EVALUATION OF THE WIPP PROJECT'S COMPLIANCE
WITH THE EPA RADIATION PROTECTION STANDARDS
FOR DISPOSAL OF TRANSURANIC WASTE

Environmental Evaluation Group
7007 Wyoming Blvd., NE, Suite F-2
Albuquerque, New Mexico 87109

March 1998

Figure 2. Overall Mean of Normalized Releases for Modeling of increased solubilities using Nesquehonite and ‘No Backfill’ Values compared to CCA values.

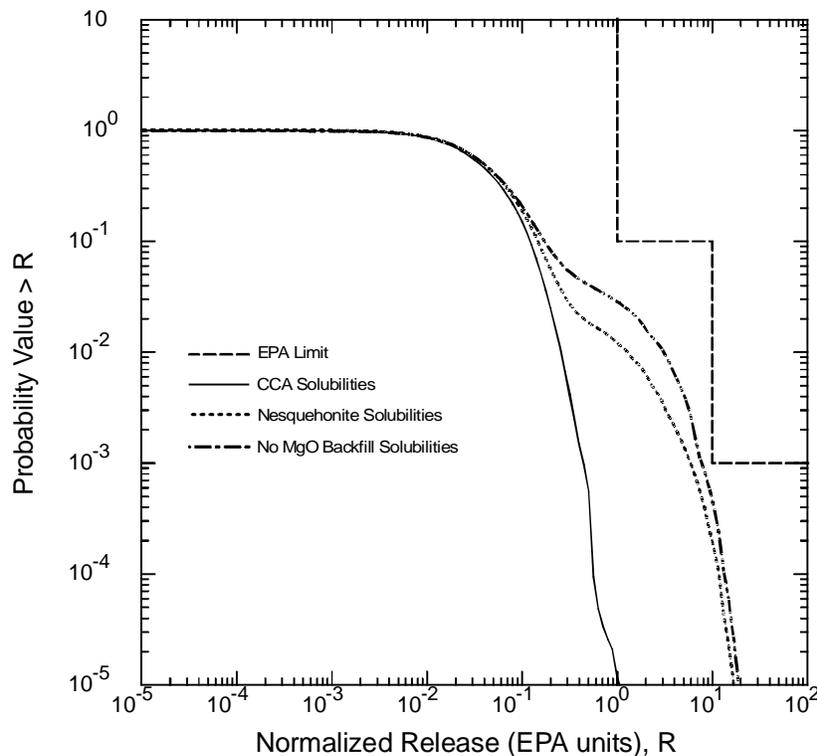
The results of running new solubility values can be seen in Figure 2. The figure shows the overall mean of all processes combined as they relate to compliance. In addition, the PAVT direct brine releases were run with the slightly higher CCA solubilities. The most distinct feature of the figure is the shoulder of the high solubility models that extend below the 10^{-1} probability limit. The “shouldering” is the effect of increased releases due to the direct brine release. Since the Pu+4 and Th+4 (although minor) solubilities increased over 5 orders of magnitude, the release due to this mechanism is expected to increase significantly as well. For example, the CCA median value for +4 actinide solubilities in Castile brine was 6×10^{-9} M. If one assumes 100 m^3 of Pu^{239} brine, then it is expected that the release is 2.5×10^{-5} EPA units. If the solubility is increased by $10^{5.23}$ as seen in Table 1., then it is expected that 4.24 EPA units are released to the accessible environment. Therefore, the CCDF for higher solubilities would be closer to the EPA limit.

The consequences of higher solubilities, as seen in Figure 2 are quite high. The overall mean

release for the CCA and PAVT were 0.2 and 0.4 EPA u at 10^{-3} probability, respectively. The overall mean for the increased solubilities of nesquehonite and 'no backfill' are 6.0 and 8.0 EPA units at the 10^{-3} probability, respectively. The limit for compliance, according to 40 CFR Part 194 is 10 EPA units. Therefore, it appears that even high solubility values do not cause the disposal to be out of compliance with the EPA regulations. However, there is a deeper issue that one cannot dismiss, that is far less superficial than the previous statement. It deals with the consequences in small changes of solubility and variability in the actual values. Are we so certain that the solubilities of Plutonium or Uranium, in any oxidation state, are less than the values presented in the CCA or the PAVT? How did we arrive at these numbers? Are there experimental evidence to back up the claims made in the CCA that deals with the oxidation state analogy between Am+3 and Pu+3? Once one really delves into the reasoning behind many of the fixed numbers associated with these actinides, many deficiencies appear in the reasoning, and confidence in the values used to show compliance declines.

Figure 3. Contiguous Failed Volume as a Function of Increasing Waste Permeability for Different Waste Strengths With Initial Repository Pressure of 14.5 MPa.

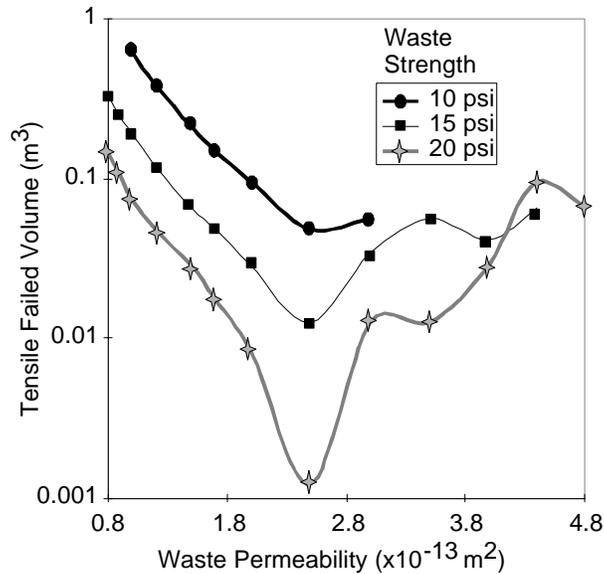
The reported failed volumes outside the range for the Base Case are extremely high, resulting in as much as 22.5 m^3 for a permeability of $0.5 \times 10^{-13} \text{ m}^2$ due to the cascading affect of multiple zone failure. The geometry of the borehole cavity was discretized and solved on a hemispherical coordinate system. The layers of the hemisphere were kept to a minimum (0.01 meters) to avoid instability. When the waste in the borehole fails, it is assumed that the whole layer fails, and peels off like an onion skin. When the code calculates a large failed volume, as in the case with $0.5 \times 10^{-13} \text{ m}^2$ permeability, the effect is several layers peeling off in one time step, cascading until an equilibrium is reached with the high pressure gradient that existed at a longer time period. It is assumed that when the cascading effect is exhibited, the results become meaningless.

Figure 3 shows some interesting results as the waste permeability increases. All the waste strengths tested showed an exponentially decreasing failed volume, up to a permeability of $2.5 \times 10^{-13} \text{ m}^2$. Permeabilities above this value cause larger failed volumes than values below it. The upper limit on permeability shows that the code is reliable to $2.5 \times 10^{-15} \text{ m}^2$ for waste strengths that were measured in the report by Hansen et al. (1997) and initial repository pressure of 14.5 MPa. The lower permeability limit is $1.0 \times 10^{-13} \text{ m}^2$ for 10 psi waste strength, and decreases to $0.8 \times 10^{-13} \text{ m}^2$ for waste strengths of 15 and 20 psi.

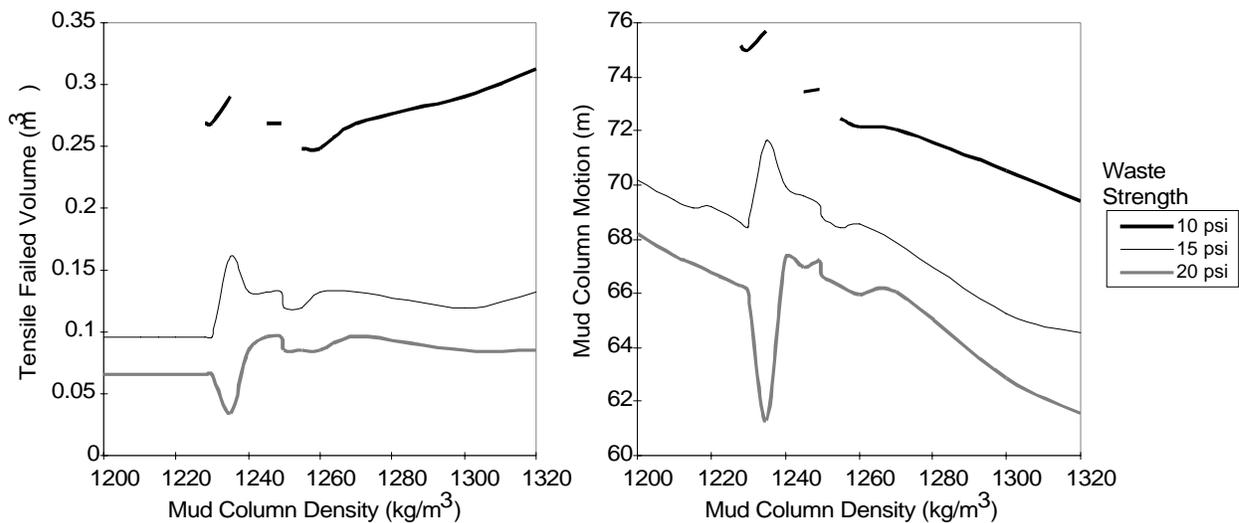
Figure 4 shows the results of varying the parameter from 1200 to 1320 kg/m³ for a 10 second simulation and an initial repository pressure of 14.8 MPa. The figure shows three curves of different waste strength, with all other parameters remaining the same as used in the Base Case simulation. The most outstanding feature of Figure 4 is the disjointed curve of failed waste (left) and mud motion (right) of the 10 psi tensile waste strength simulation. The code had trouble calculating failed waste for mud densities below 1228 kg/m³, resulting in the cascading affect described above. The code also had trouble at 1240 and 1250 kg/m³, and if results were plotted for these densities (failed waste and mud motion), sharp spikes would exist in the curve.

For the higher waste strengths (and subsequently lower repository pressures) of 15 and 20 psi, the mud density simulations were able to calculate failed volumes for all density values investigated. However, the results seemed almost as unreliable as the lower waste strength. Though a trend can be seen in the failed volume and mud motion, variances from those trends are high. Both graphs in Figure 4. show trouble with densities between 1230 to 1270 kg/m³.

Figure 7. Failure Volume (m^3) vs Time (s) for Different Waste Permeabilities. The results are from GASOUT with the option of 'failed material removal' turned off.

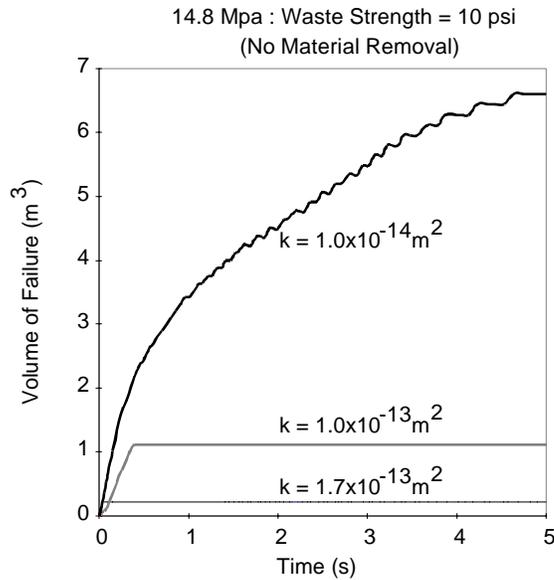
For an extreme example of the above analogy, Figure 7 shows radial distance of potential failure at permeabilities of 1.7×10^{-13} and 1×10^{-14} m² for pressures at 14.8 MPa without material removal. Potential failure was extrapolated from the effective stresses that would exist in non-failed material. The repository pressure was set at 14.8 MPa and waste strength at 10 psi for the experiments in Figure 7.

The figure clearly shows that when permeability is lower than assumed in the CCA then releases will be higher than assumed from the investigation in Hansen et al. (1997). The maximum radial failure at a permeability of 1×10^{-14} m² is 1.17 m, equating to an uncompacted spalled volume of 6.6 m³. It is believed that when permeability is even lower than the lowest value presented in Figure 7, the releases could be higher. However, the code has difficulties with oscillations in pressures at lower permeabilities, and confidence in results is low.

The results of Figure 7 must be kept in context. When material is not removed during the pore pressure calculations (and subsequently total overburden stress), the code does not redistribute values at the new boundary. Instead, the pore pressures decrease in that region, hence lowering the possibility of new failed material. Therefore, Figure 7 actually underestimates the potential effect of failure, and higher volumes will result if the material is removed. These calculations are not possible with GASOUT, with reasons explained from the sensitivity analysis with the code.

Figure 11. Effective Radial Stress As A Function Of Radial Distance For The EPA's Air Drilling Analysis.

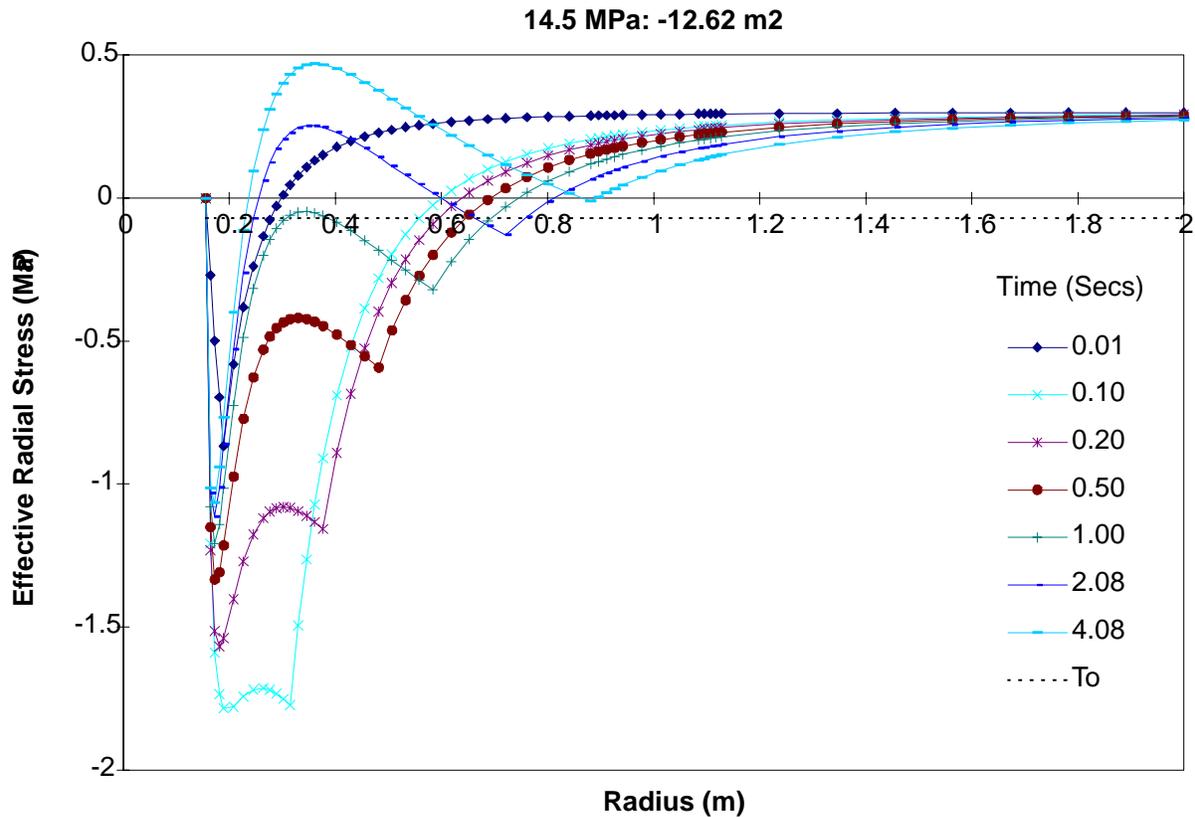
The results of air drilling from the EPA's analysis at WIPP is reproduced here in Figure 11. The figure shows effective stress versus radial distance within the repository at several times during the simulation. The EPA judged failure in this figure by estimating the point at which the effective stress is less than the strength of the material (indicating high pore pressure). This point is at 1 second from the beginning of the simulation, with a radial failure distance of 0.69 m (1.4 m³ of uncompacted waste). After 1 second of simulation time, the pore pressure in the waste near the cavity begins to decrease, and the effective stress moves upwards (increases positively) towards the region of higher total stress.

Intuitively, the results shown in Figure 11 would raise questions about the behavior of the system. Why does the effective stress sharply decrease from 0.01 seconds to 0.1 seconds then gradually rise throughout the remainder of the simulation? Does the system stop predicting failure after 1 second? What is the effect of tangential stresses in the waste? How does the system respond to varying repository parameters? All of these questions are relevant to the understanding of the Quasi-Static model and to the prediction of stresses in the waste from an air drilling event.

Figure 12. Effective Stress, Total Stress, and Pore Pressure Profiles in the waste at three independent times from the EPA’s Analysis of Air Drilling.

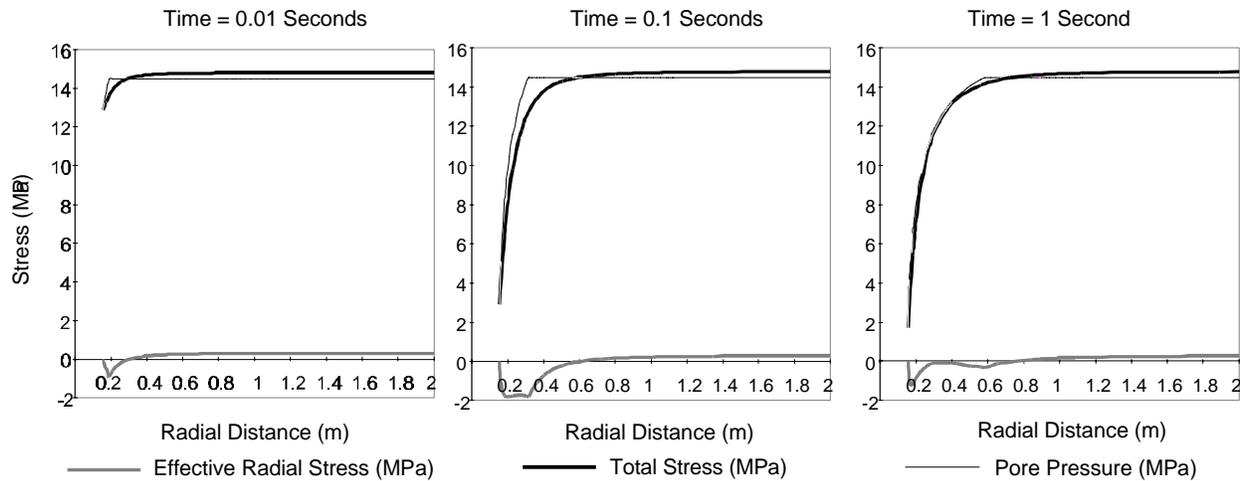
The effective stress is simply the difference in the calculated total stress and calculated pore pressure. Figure 12 shows the relationship between these quantities for three separate times for the EPA's analysis of air drilling. The left plot shows the first time step, at 0.01 seconds from time of intrusion. One can see immediately that waste failure occurs due to a slightly higher pore pressure, with the radius of failure being 0.27 m. The relatively large failure at this time is due to the unsmooth function of the pore pressure in the waste, which carries over to the effective stress. The same can be seen the two other plots of 0.1 and 1 second from intrusion time. The effects of the unsmooth pore pressure profile average out as the time from intrusion increases, but is one the reasons for increase in effective stress at later times.

The code also only approximates the pore pressures in the repository by assuming steady flow. As seen in Figure 12 (above), the steady flow assumption causes the pore pressure profile to be unsmooth. This characteristic, when combined with total stress of the overburden rock, produces oddly varying effective stresses in the waste. This shows that the code produces unreliable results for an air drilling scenario. When effective stresses are compared to the results of a code that calculates the time-dependent flow and pore pressures (Figure 13, above), the effective stresses are much lower (higher in the negative direction) than the Quasi-Static model at early times. Beyond the first couple of time steps, the code starts to be less accurate, and pore pressures begin to decrease in waste that should have been removed.

Figure 14. Yield Potential for EPA Air Drilling Analysis. The Figure Represents Equation 2 (above) vs. Radial Distance. Yield Will Occur When the Potential is Greater than Zero.

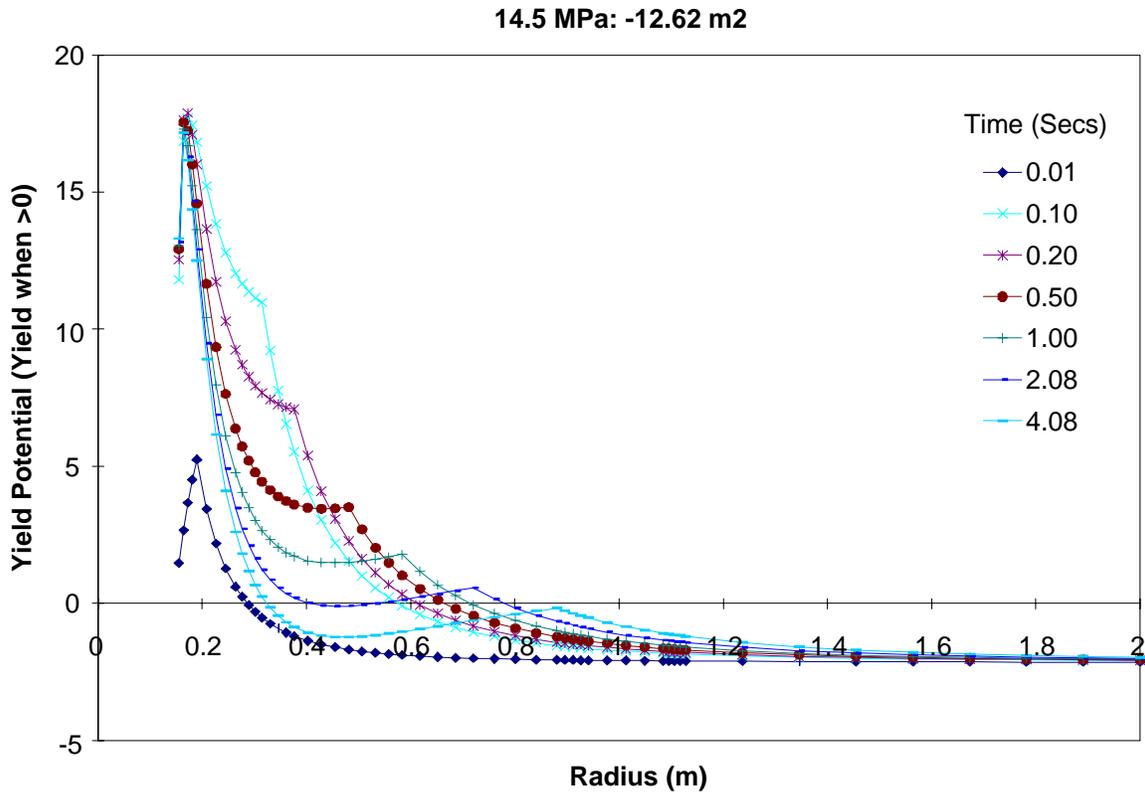
Figure 14 shows the results of Equation 2.5-2 plotted against radial distance. The first observation is that there is potential for yield out to 2 seconds from the time of intrusion. The yield crosses the axis at approximately 0.8 m, resulting in an uncompacted volume of 2.1 m³. This is an increase of 33% from the initial estimate stated in the EPA's analysis. The curves also seem to be highly influenced by the discontinuity in pore pressure calculations, and can be seen in Figure 14 by the second peak in the curve as radial distance increases. When compared to the yield potential calculated from GasOut, which calculates a smooth function of pore pressure, the limit for yield is 0.7 m at 0.1 seconds from intrusion (as compared to 0.6 m from the Quasi-Static model). After this time the yield is essentially zero.

Figure 15. Effective Radial Stress As A Function Of Radial Distance For An Increased Pressure For The Air Drilling Scenario.

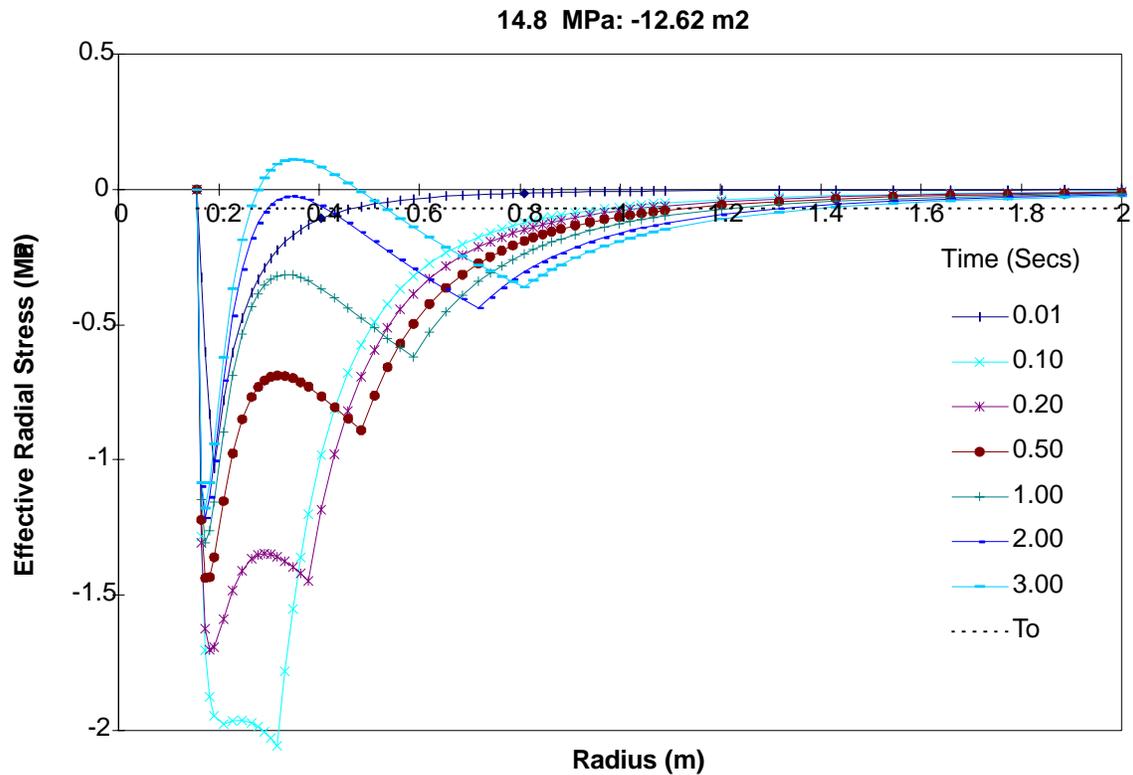
To demonstrate the response of the model to different input assumptions, Figure 15 shows a simulation in which the repository is increased from the nominal 14.5 MPa that was used in the EPA analysis to 14.8 MPa. The higher pressure is the maximum pressure that the repository will

sustain for long periods of time, and is the lithostatic pressure of the overburden rock. If gas pressures are above lithostatic, the weak stratigraphic layers will fracture until sufficient energy is released and the pressure returns to the minimum fracturing pressure. The results of Figure 15 are astounding. The figure shows that a nominal increase in pressure will significantly increase potential releases. At 1 second after initial intrusion, the radial distance of failure is 1.22 m (7.58 m³ of uncompacted waste). Although not shown, the waste will continue to fail during the entire 9 second simulation, in which the radial distance increases to approximately 1.65 m (19.1 m³ of uncompacted waste). These volumes are greater than the 4.0 m³ maximum calculated in the CCA, and perhaps would have an impact on the CCDF calculations if air drilling scenarios were considered in the CCA.

Fig. 19. Comparison of Approved Injection Pressures For Salt Water Disposal Well Versus Oil Field Water Flood Wells Near WIPP.

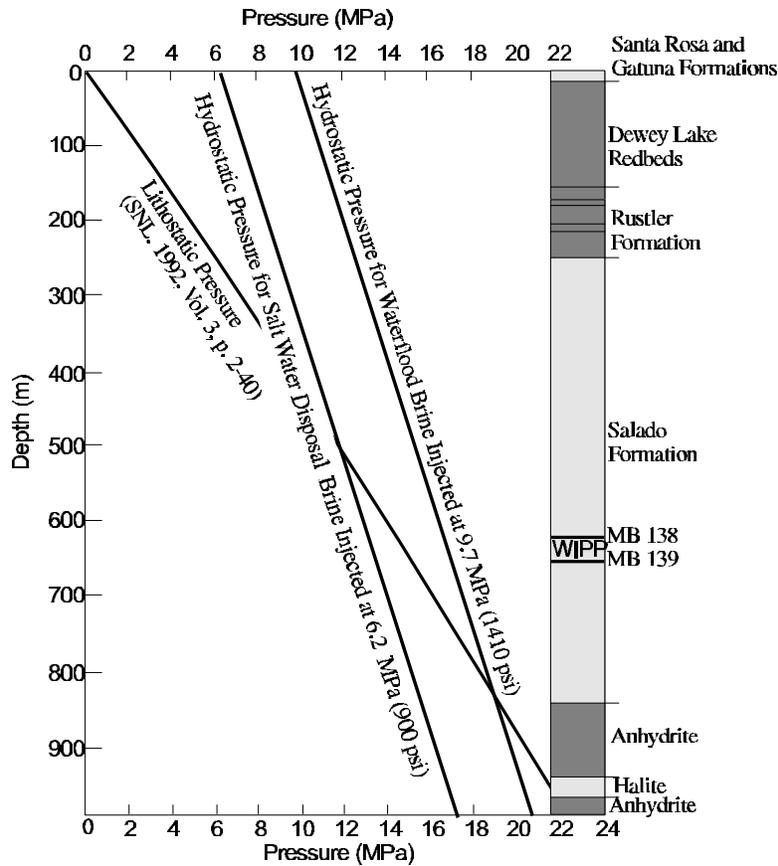
WIPP. Figure 19 compares the maximum approved disposal pressure for two wells one mile to the east of the WIPP Site. EEG is not suggesting that either of these wells are leaking. But EEG notes that in the event of a leak near WIPP current approved salt water disposal pressures are not sufficient at the repository horizon to exceed the lithostatic pressure. Only a leak in the waterflood well would be of concern to the repository. This is an inherent result of the greater vertical distance to the oil producing horizons. The DOE and EPA rationale appears to be more appropriate for the more shallow oil and gas reservoirs in the Vacuum Field area and the Rhodes Yates area and not suitable for the WIPP area. Presumably, carbon dioxide for enhanced oil recovery would be injected into the deeper oil producing zones and at sufficient pressures to maintain a miscible displacement. Hence, given the observation above, EPA can not conclude that the salt water disposal well analyses captures the CO₂ flooding scenario.

Fig. 20. Solution Mining of Brine and Natural Gas Storage Wells.

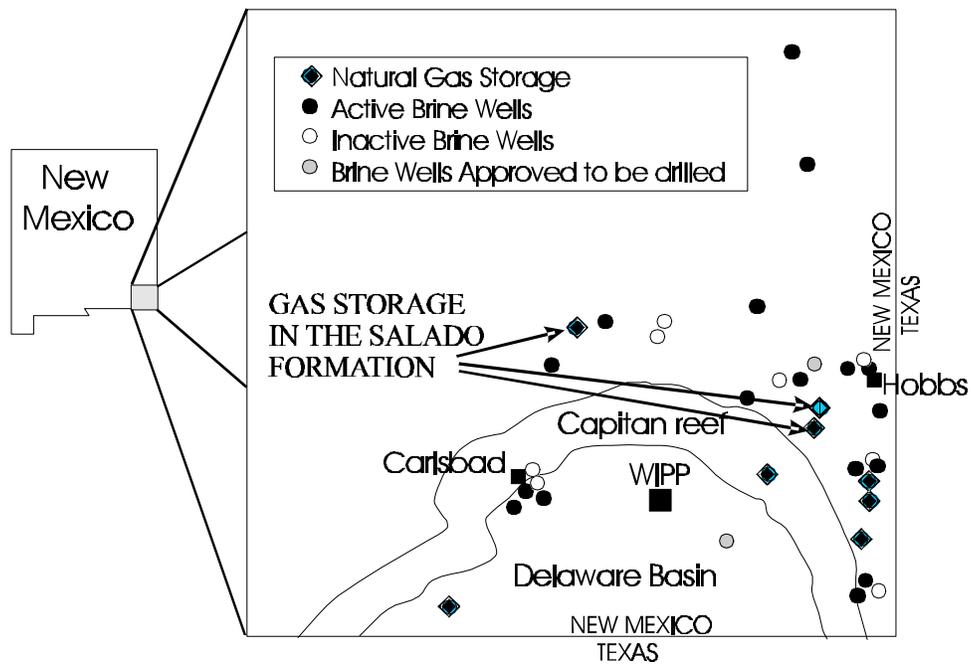
As shown in Figure 20, there are three solution mining operations for brine production near the city of Carlsbad area and at least 16 miles from the WIPP site. EPA mentions only one about 14 miles from the WIPP Site. Furthermore, EPA does not discuss the trend towards drilling brine production facilities closer to WIPP. Brine well BW-26 has been approved for production from the Salado Formation. The solution mining operation would be located between Jal and Carlsbad to meet the demand for drilling brine. The well was approved to remove salt from the Salado formation which lies between 1500 to 2300 feet deep. The subsidence calculations provided by DOE were for a facility that is 583 feet deep.

Solution mining of the Salado Formation is an important observation. It is important for EPA to
